Board of Trustees Regular Meeting Agenda Hartland Township Hall Tuesday, November 29, 2022 7:00 PM

Submitted By: Troy Langer, Planning Director

Subject: Site Plan with Special Land Use Application #22-015 (Mini warehouse establishment with outdoor storage as accessory to a permitted use)

LP-1 LANDSCAPE PLANTING PLAN

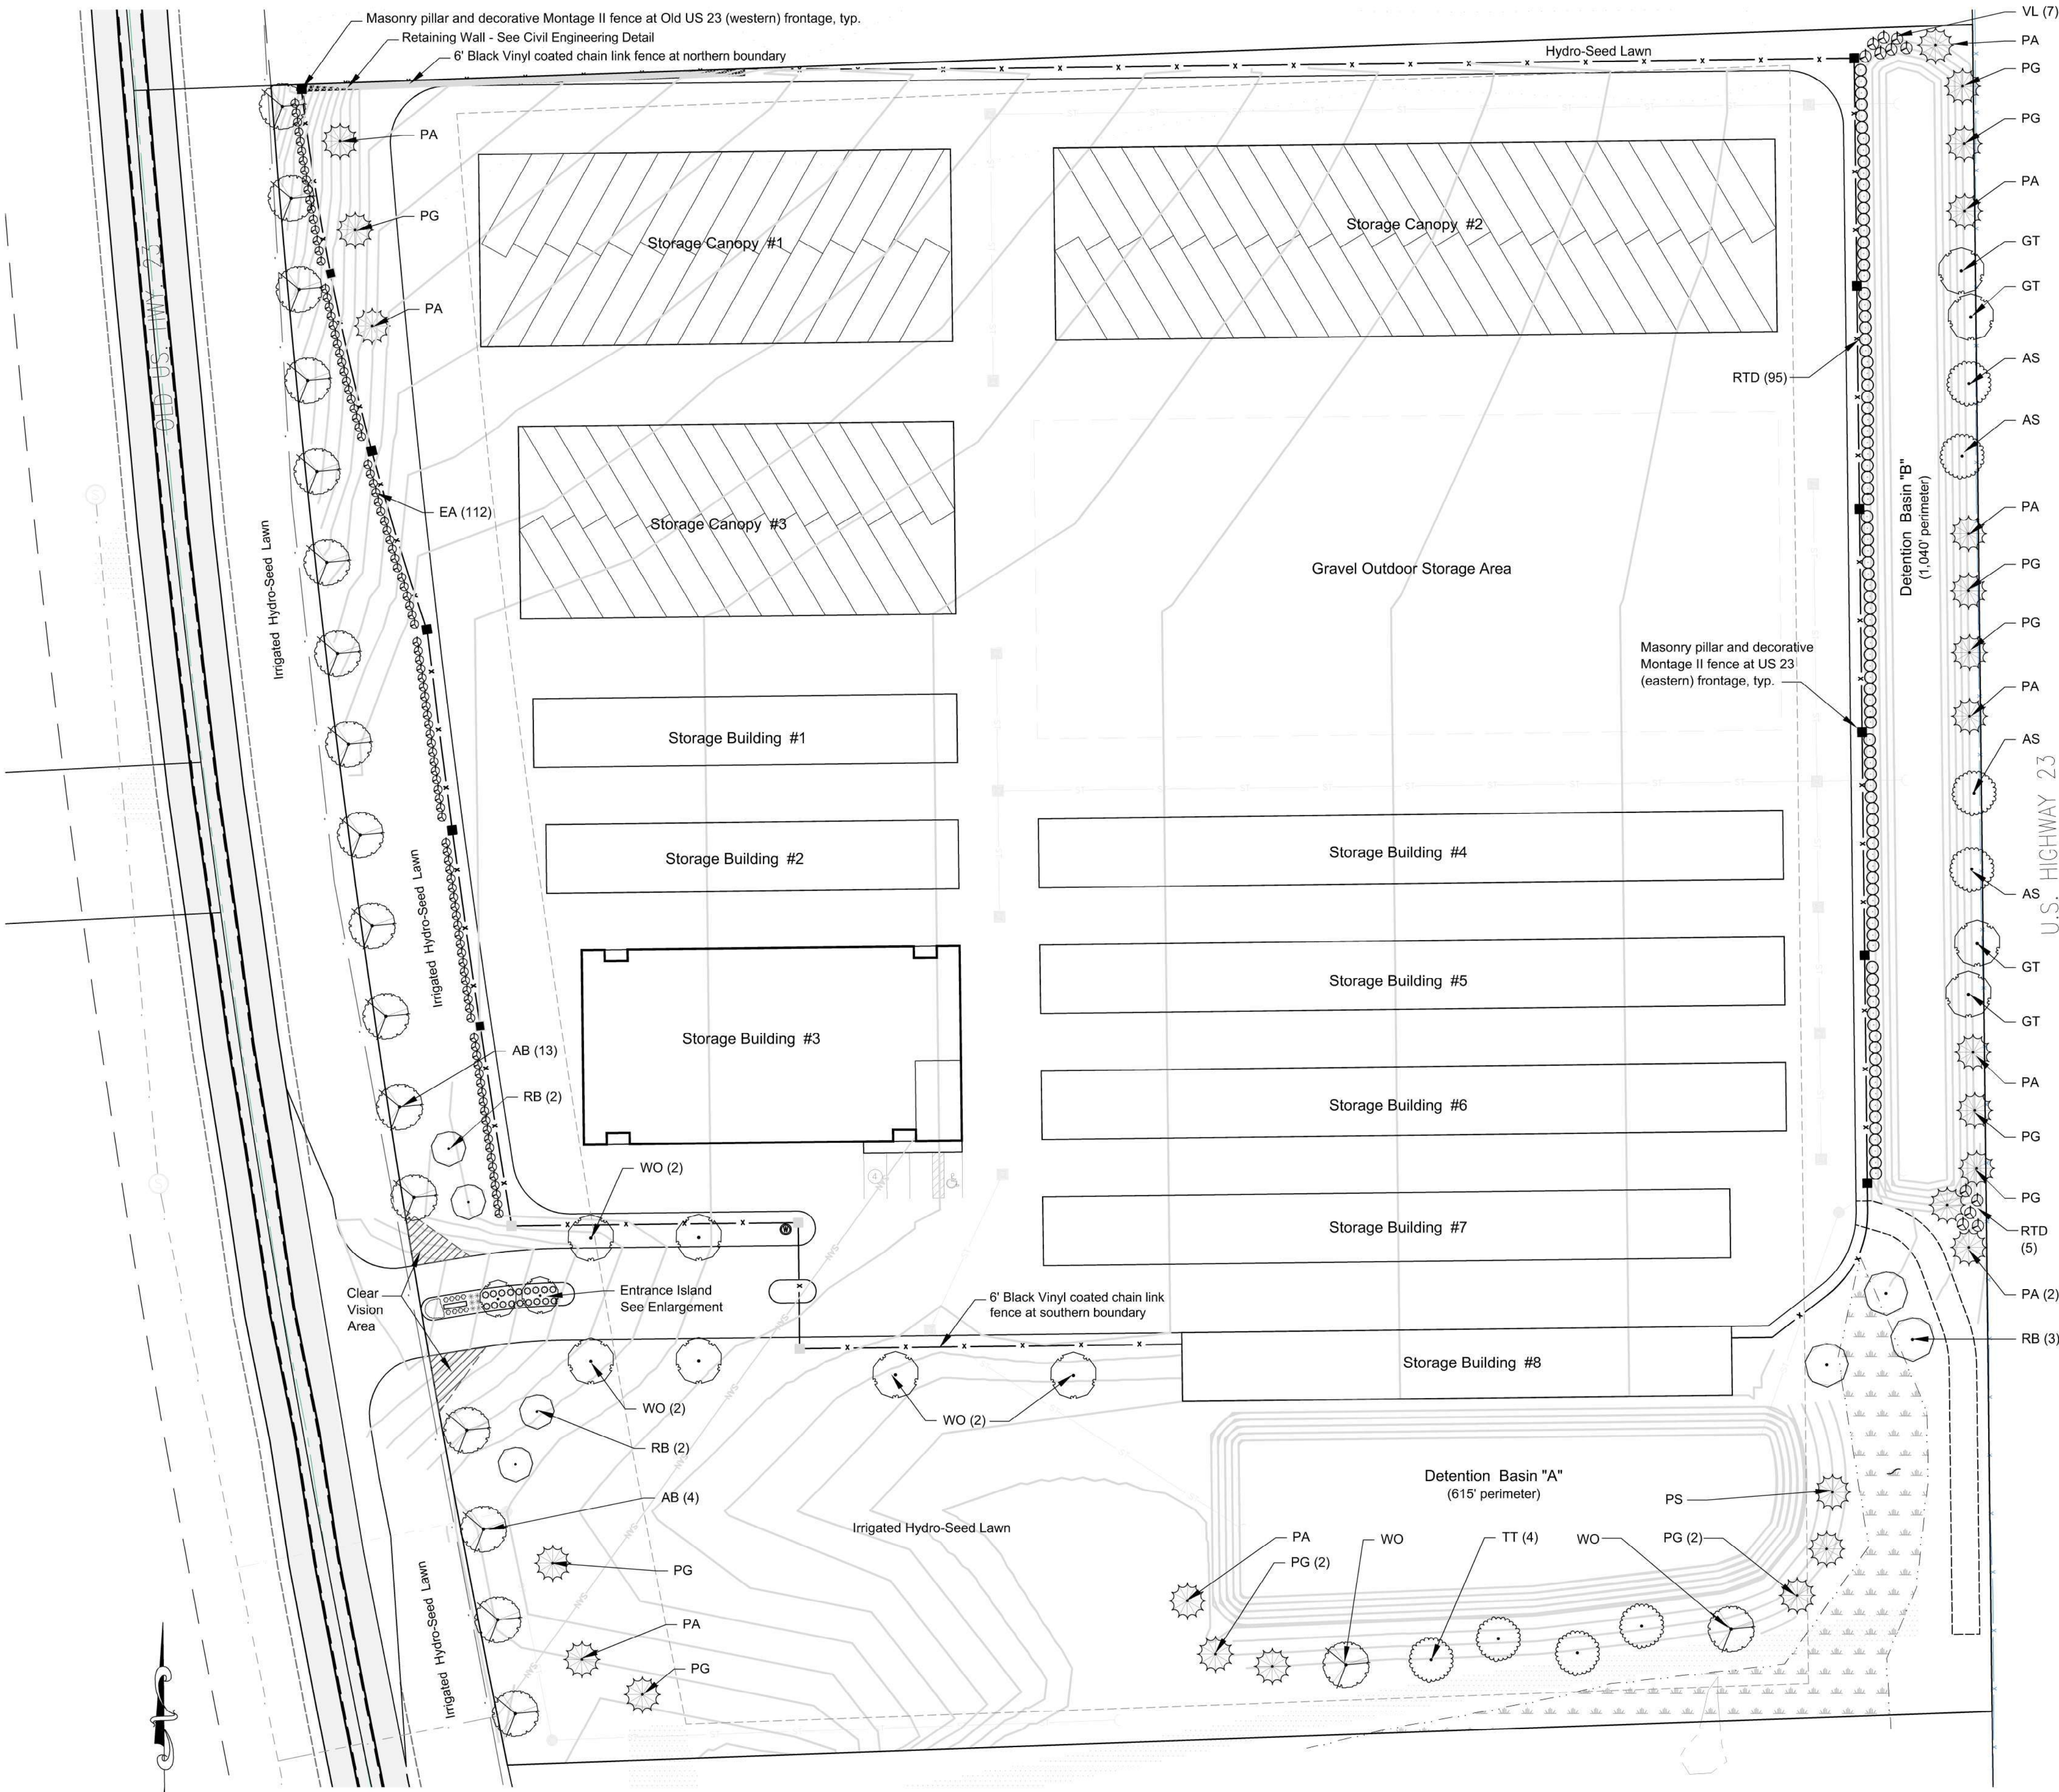
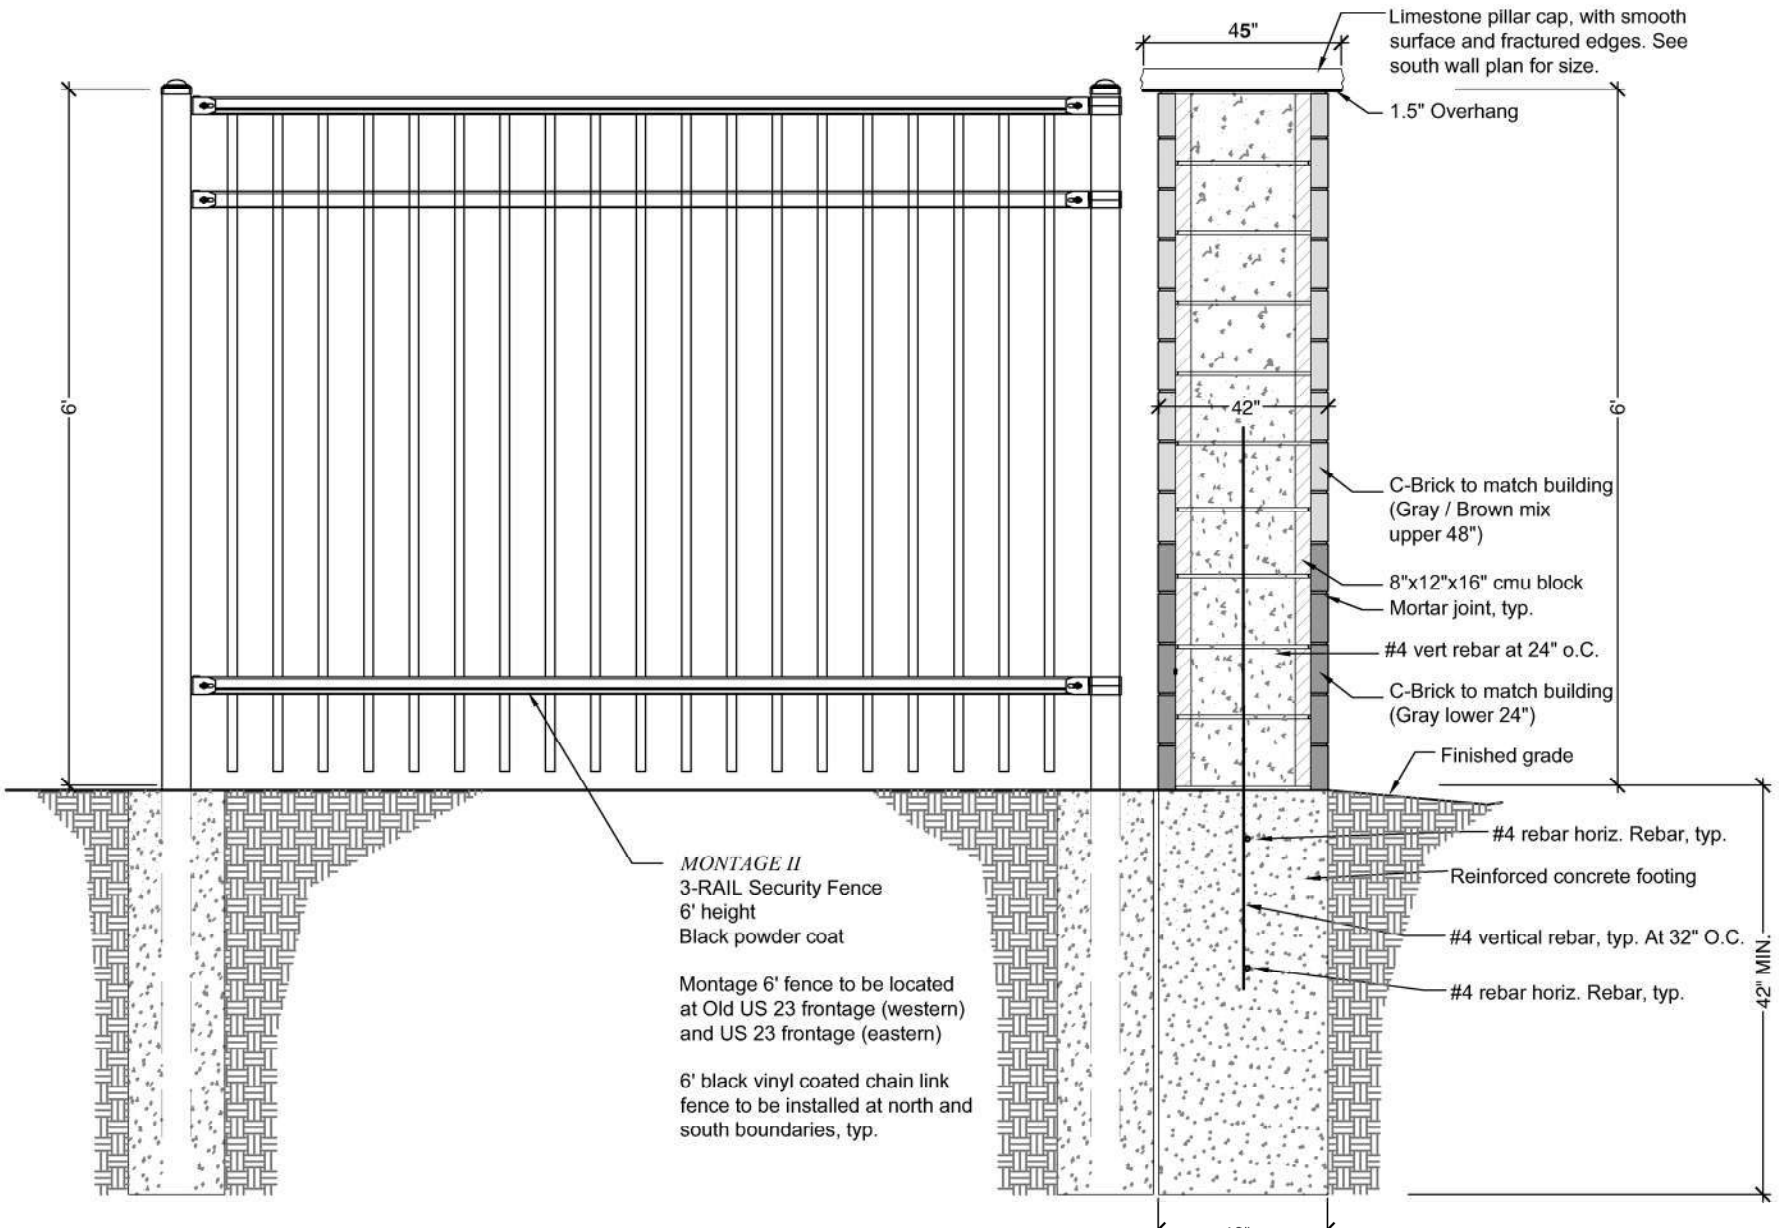
- Proposed – 12 trees (6 deciduous and 6 evergreen trees); 0 shrubs
 - Meets Requirement? – **TBD for number of shrubs**
 - Comment – Applicant has provided a note on Sheet LP-1 stating Detention Basin A is adjacent to Wetland A. Detention shrubs were not provided in lieu of existing wetland plants and scrub growth associated with the wetland area, per the applicant. Planning Commission to determine if this meets the intent of the ordinance requirements.

Some of the plant counts listed on Sheet LP-1 (Landscaping Plan) for the landscape calculations do not match the number of plant symbols shown on the landscape plan. Also, several plant name abbreviations are stated but the plant name is not listed in the Plant List (AS, TD, and VL). A revised landscape plan shall be submitted as part of the Construction Plan set.
